CUSTOMER NOTIFICATION

SUD-DT-04-0197 (1/7)

IE-703217-G1-EM1
(Control Code: A, B, C, D)

Operating Precautions

No.5 Restriction on interrupt request flag

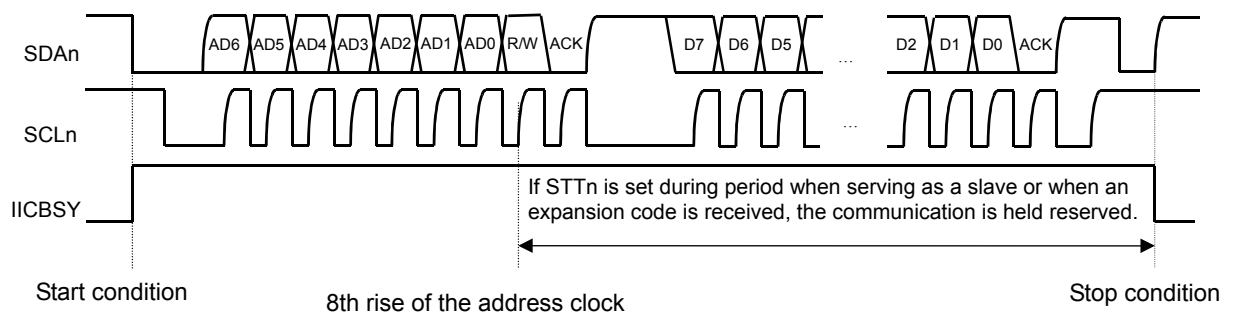
The interrupt request flag is not cleared even if an interrupt request has been acknowledged.

Add processing to clear the interrupt request flag at the beginning of the handler address of the acknowledged interrupt. Clearance of the interrupt request flag can be performed by instruction execution.

This restriction has been corrected in control code B.

No.7 Restriction on transmit data write using 3-wire serial interface with automatic transfer function

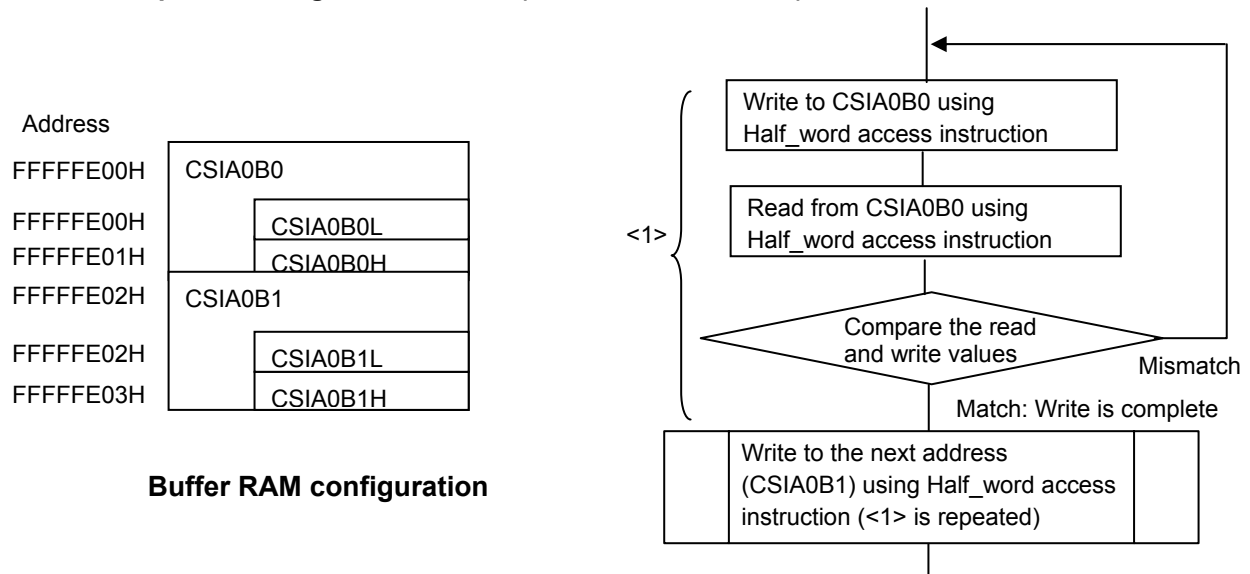
When writing transmit data to the buffer RAM (CSIANBm) using the 3-wire serial interface with automatic transfer function (CSIAN), data may not be written correctly depending on the instruction executed next to the write instruction (n = 0 or 1, m = 0 to F).

This restriction is not applicable under the following condition.

Condition: CSIAN input clock (f_{SCKA}) is faster than the CPU operating clock (f_{cpu}) \times 10

$$f_{cpu} \times 10 < f_{SCKA}$$

Implement any of the workarounds shown below by software. To avoid this restriction, it is required to use instructions with the same access length until the write is complete.

Workaround (1)

After data is written, read the data using the Half_Word access instruction (ST.H) and compare the values. If the data do not match, perform the write again. At this time, it is not necessary to disable interrupts.

Workaround (2)

Disable interrupts using the DI instruction and write data to the buffer RAM using the Half_Word access instruction (ST.H) only. In addition, re-write the last 2 bytes of the written data again. Do not execute instructions other than NOP and operation instructions between when data is written to the buffer RAM and when the last 2 bytes are rewritten.

Workaround (3)

Disable interrupts using the DI instruction and write data to the buffer RAM using the byte access instruction (ST.B) only. In addition, execute a NOP or operation instruction equivalent to 5 or more input clocks selected by bit 6 and 7 (CKSAn1 and CKSAn0) of CSISn after the last data is written to the buffer RAM.

This restriction has been corrected in control code C.
